Re: Florida Power & Light Company
Proposed Turkey Point Units 6 and 7
Docket Nos. 52-040 and 52-041
Response to NRC Environmental Request for Additional Information Letter 1103094 (RAI 5563)
Environmental Standard Review Plan Section 9.3 – Alternative Sites

Re: Florida Power & Light Company
Proposed Turkey Point Units 6 and 7
Docket Nos. 52-040 and 52-041
Response to NRC Environmental Request for Additional Information Letter
1103094 (RAI 5563) Environmental Standard Review Plan
Section 9.3 – Alternative Sites

NRC RAI Letter No. 1103094 Dated March 9, 2011

NRC RAI Number: EIS 9.3-1 (RAI 5563)

**GLADES
CONCEPTUAL SITE LAYOUT**

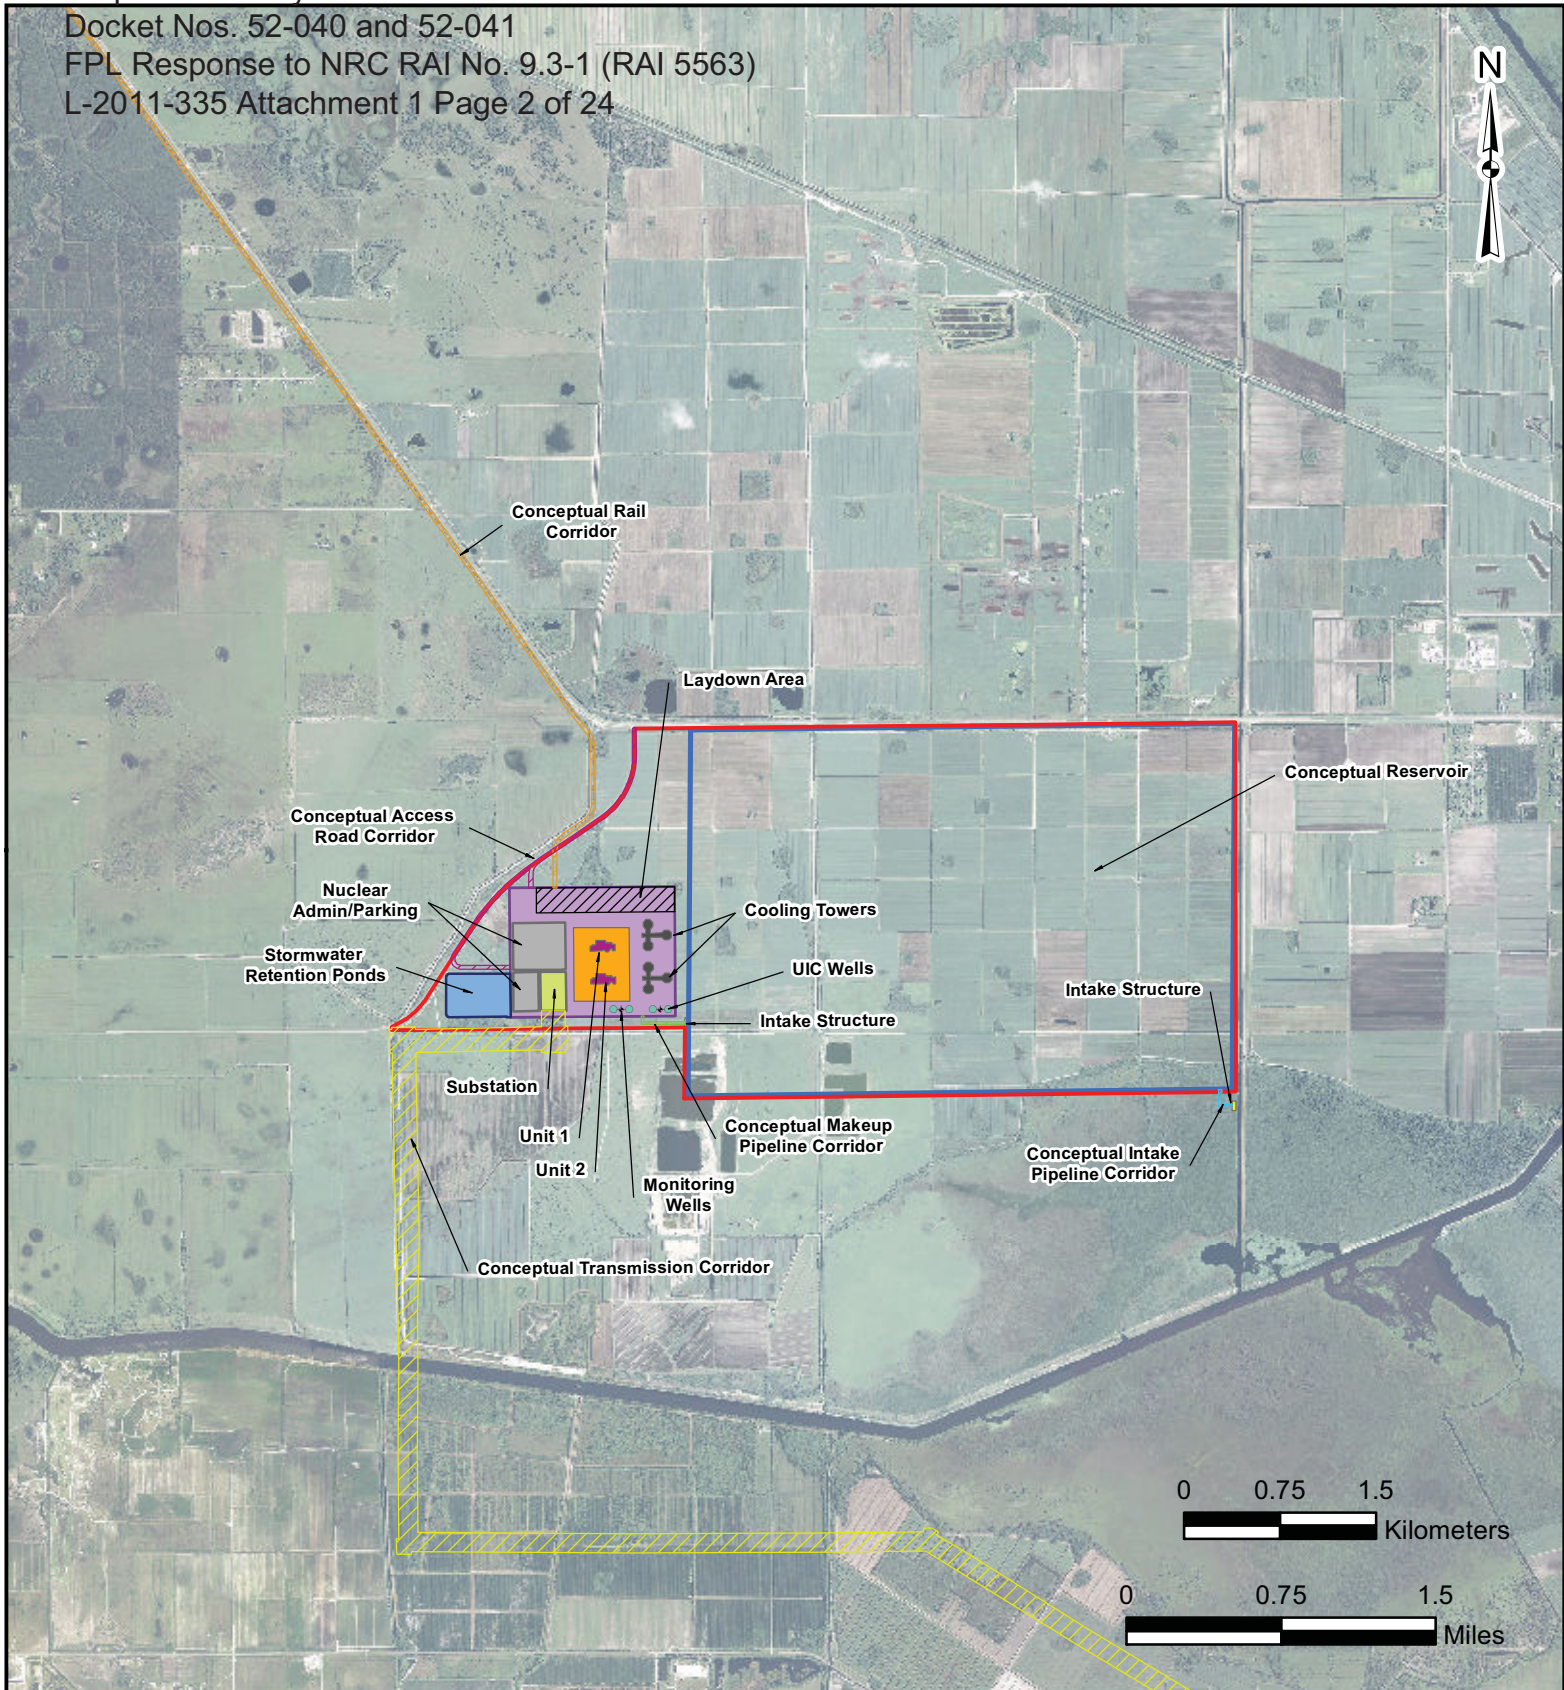
For each alternative site, provide a map showing the site boundaries, assumed facility footprint, and land cover types based (if possible) on 3 digit FLUCCS codes. Provide estimates on area of each land cover type affected for each alternative site. Provide GIS layers so that the review team can independently verify the data. The staff requests this information in order to characterize the baseline ecological conditions at each site, and to provide a common basis for comparing the ecological impacts of each site.

- Figure 1 (4 pages, 1 page per alternative site) – Conceptual site layout depicting assumed site boundaries and the assumed facility footprint, including assumed cooling water storage reservoir where required.
- Figure 2 (4 pages, 1 page per alternative site) – Conceptual site layout depicting the assumed extent of non-transmission linear features, including access road corridors, pipeline corridors, and rail access corridors as appropriate.
- Figure 3 (4 pages, 1 page per alternative site) – Conceptual site layout depicting the assumed extent of conceptual transmission corridor routing.
- Figure 4 (4 pages, 1 page per alternative site) – Conceptual site layout, focused on the assumed site boundary, depicting the FLUCCS Level I land cover types. FLUCCS Level III data is included in the attached GIS files.

**GLADES
TRANSMISSION LINE CORRIDORS**

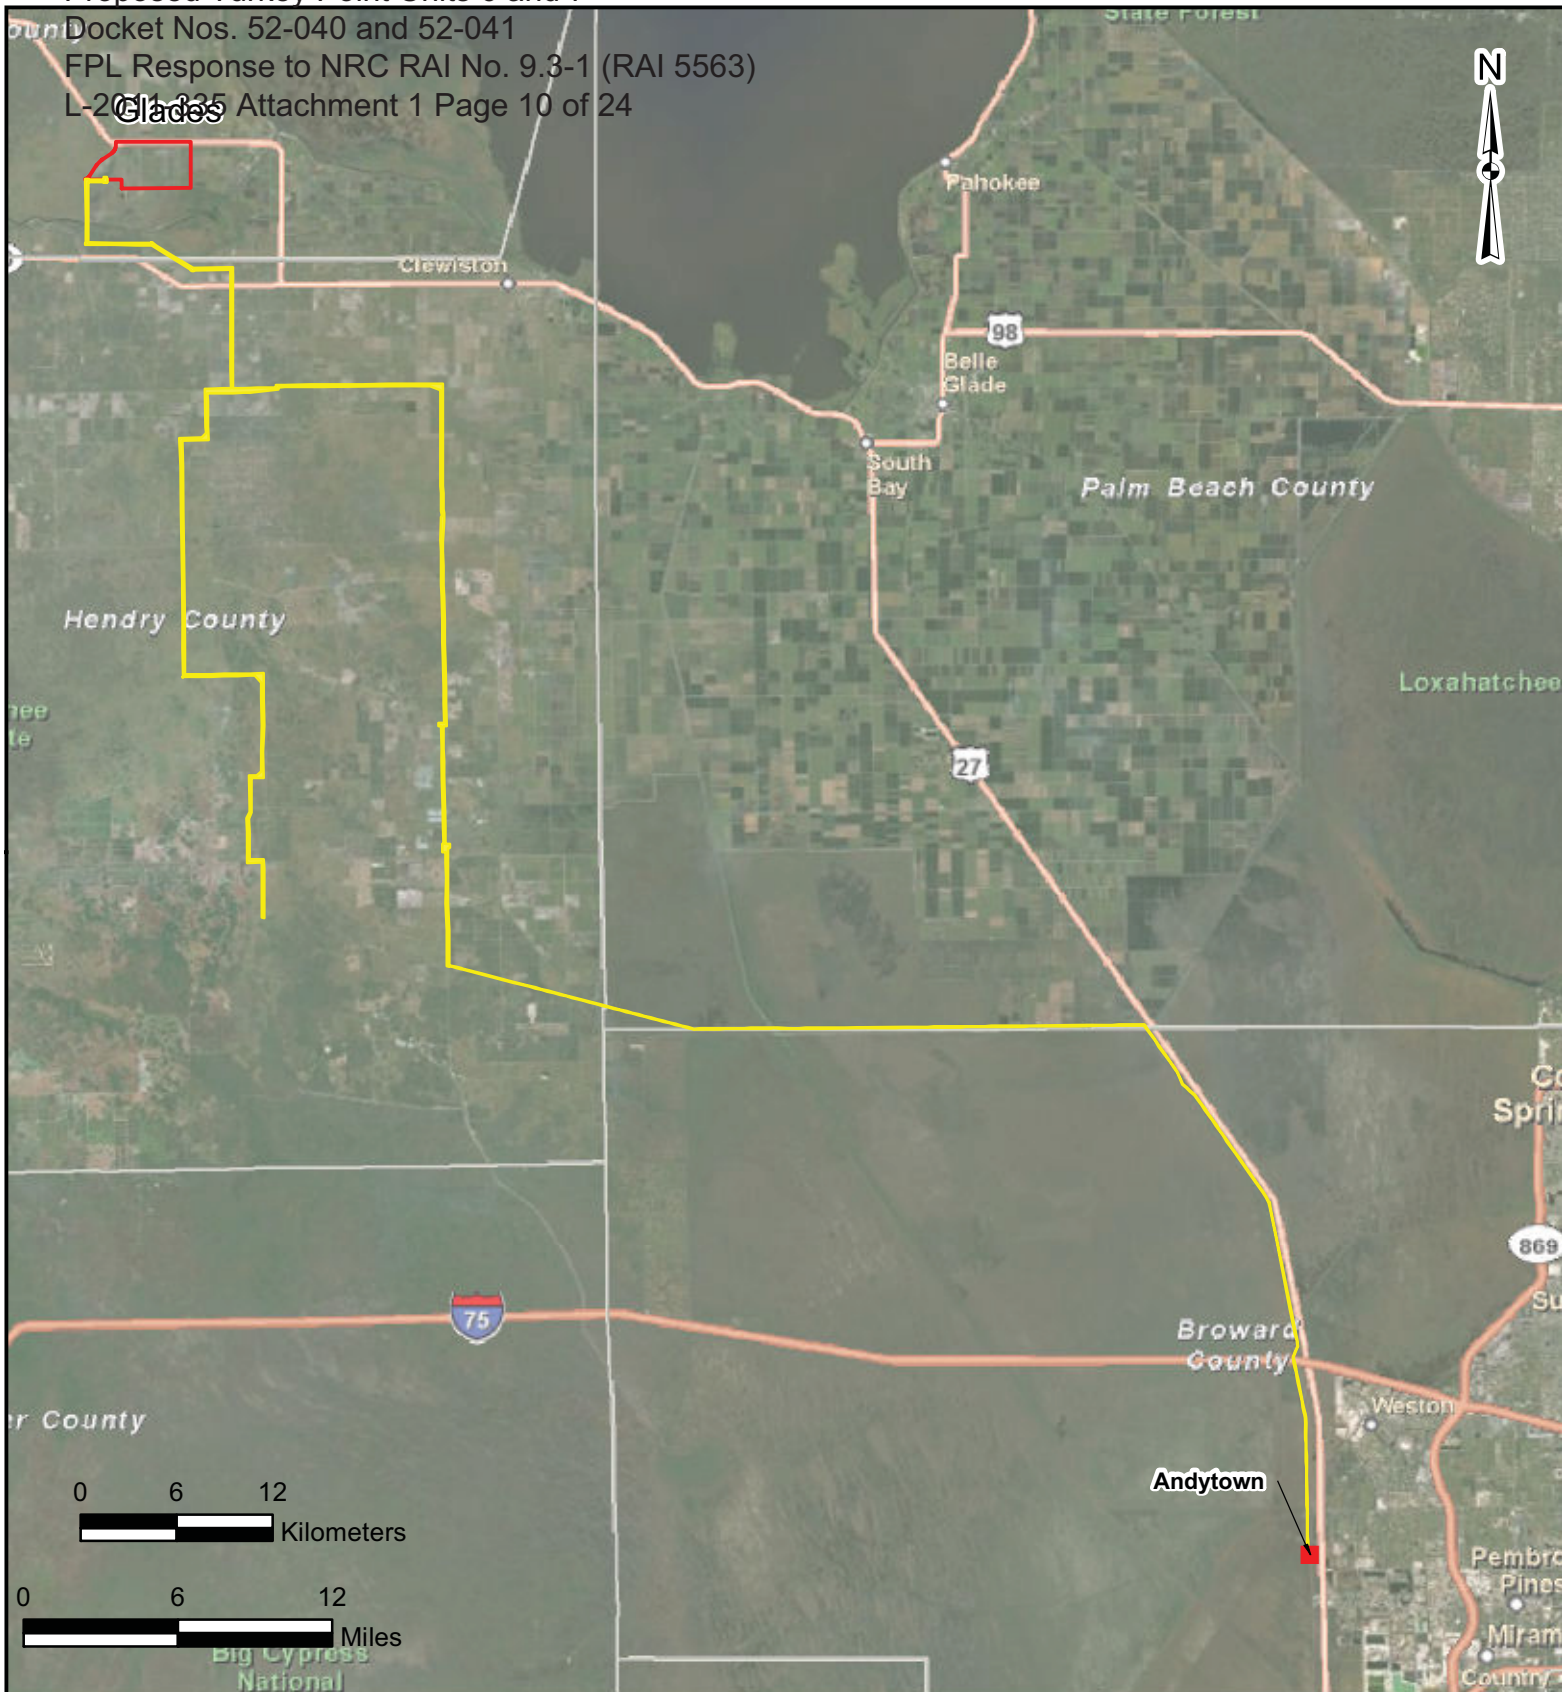
For each alternative site, provide a map showing the site, existing transmission infrastructure, the likely connection point to the regional grid, a generalized route or macro-corridor between the plant site and the connection point, and the land cover types within and near the macro corridor. Provide a summary table, using 3-digit FLUCCS codes if possible, of potentially affected land cover acreage for each alternative site. The staff requests this information in order to compare impacts among the different alternative sites. It is understood that the exact route cannot be determined at this time, but the staff can make qualitative comparisons based on generalized routes, including the proportion of the potential route that would be expected to follow existing transmission corridors or other existing linear features.

The response to RAI 5563 9.3-1 includes a figure for the conceptual site layout at each alternative site depicting the assumed extent of the conceptual transmission corridor routing (Figure 3). For each alternative site, this figure shows the assumed connection point to the regional grid and a conceptual macro-corridor route between the plant site and the connection point. A map showing the existing transmission system in the FPL service territory was included as Figure 9.3-4 in ER Rev. 2. Given the areal extent of the entire conceptual site layout (including conceptual transmission corridor routing), FLUCCS Level III data is included in the GIS files attached with the RAI 5563 9.3-1 response. In the tables below (Tables 1-4), FPL has provided estimates of the potentially affected area(s) of each land cover type (FLUCCS Level III) within the conceptual transmission corridor for each alternative site. The following transmission corridor dimensions were assumed in the conceptual transmission corridor routing:

- Glades site – assumed corridor length = 121 miles, assumed corridor width varies from approximately 200-500 ft.
- Martin site – assumed corridor length = 31 miles, assumed corridor width varies from approximately 200-300 ft.
- Okeechobee site – assumed corridor length = 38 miles, assumed corridor width = 660 ft.
- St. Lucie site – assumed corridor length = 63 miles, assumed corridor width varies from approximately 200-660 ft.
